Second Round Public Meetings
October 9, 2007/October 11, 2007

Comment Card

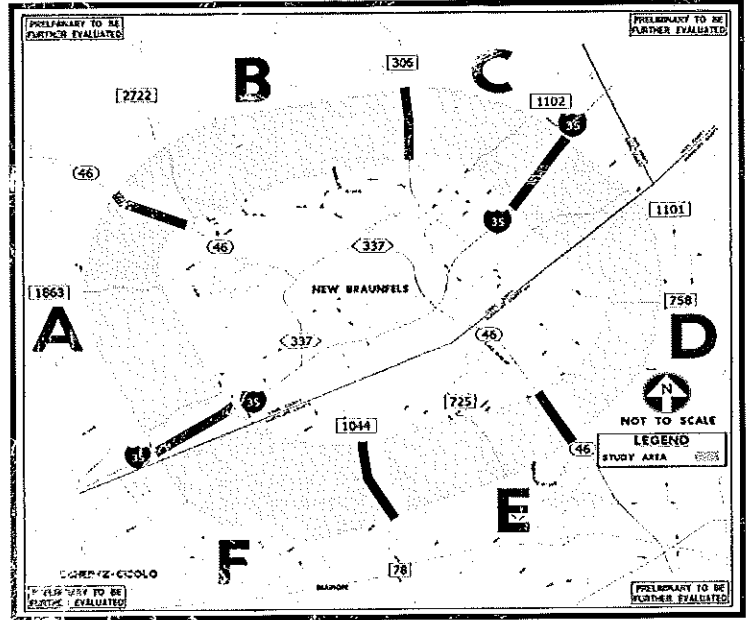
*D 6 should be deleted use a link 3 & 4
As we have seen since all the new additions going in this causes the water to funnel down from NB onto it causes even higher water & the inability to get into our homes or get out for that matter*

area in yellow needs to be changed
